**SUBJECT: Transmittal of Westinghouse Responses to Open Items Identified in the AP1000
Draft Safety Evaluation Report**

**Westinghouse Non-Proprietary Responses to
AP1000 Draft Safety Evaluation Report (DSER) Open Items**

AP1000 DESIGN CERTIFICATION REVIEW

Draft Safety Evaluation Report Open Item Response

Figure 7.2-1 (Sheet 16 of 20)

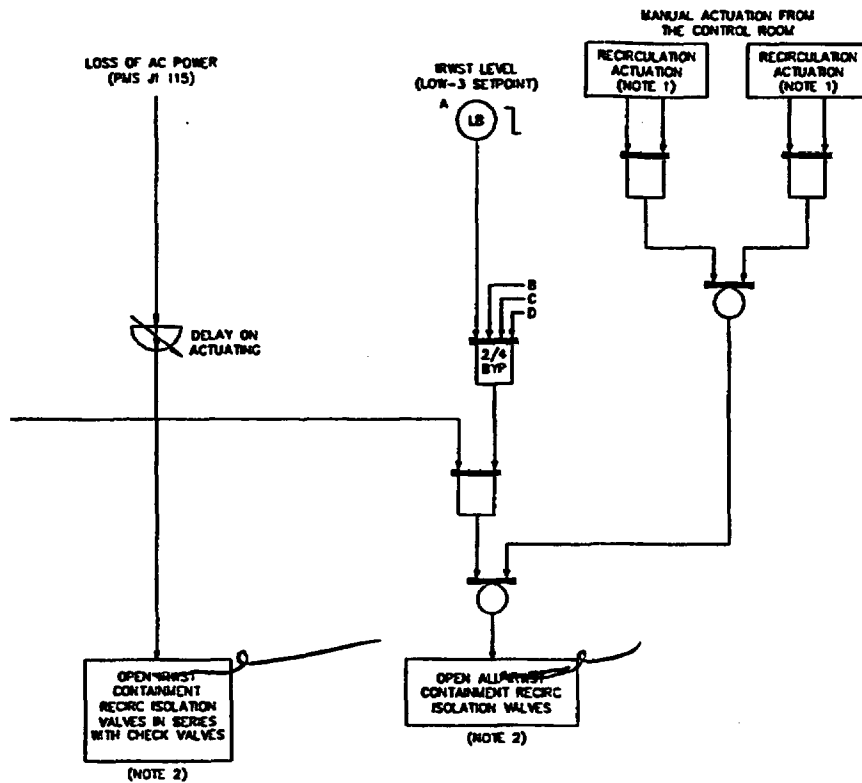
The functional logic relating to activation of the ~~in-containment refueling water storage tank~~ containment recirculation isolation valves is illustrated in Figure 7.2-1, sheets 15 and 16.

Figure 1. Illustration of the SMA Event Tree HCLPF Property

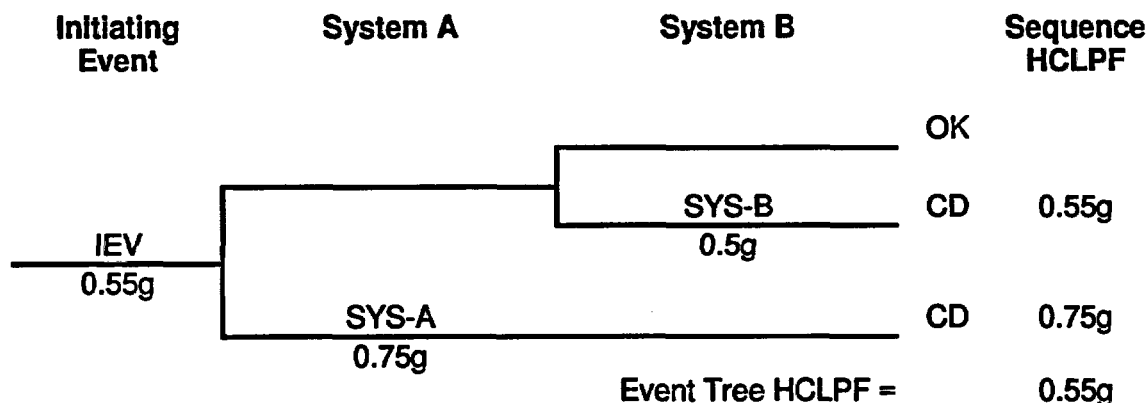
1. Every seismic CDF cutset contains an initiating event term. Thus, the HCLPF value for a cutset can not be lower than that of the initiating event HCLPF.
2. This can be visually seen as follows. Refer to Figure 1. In this figure, one of the two mitigating systems that prevent core damage has a smaller HCLPF than that of the initiating event, the other has a larger HCLPF value. Then, the event tree HCLPF value is equal to the initiating event HCLPF value.

This property enables us to calculate the plant HCLPF directly from the lowest of the initiating event HCLPFs as 0.5g, as explained in Section 55.4.2. Thus, the plant Boolean expressions are not further developed. The general conclusions and insights obtained in AP600 for the seismic margins evaluation hold for the AP1000.
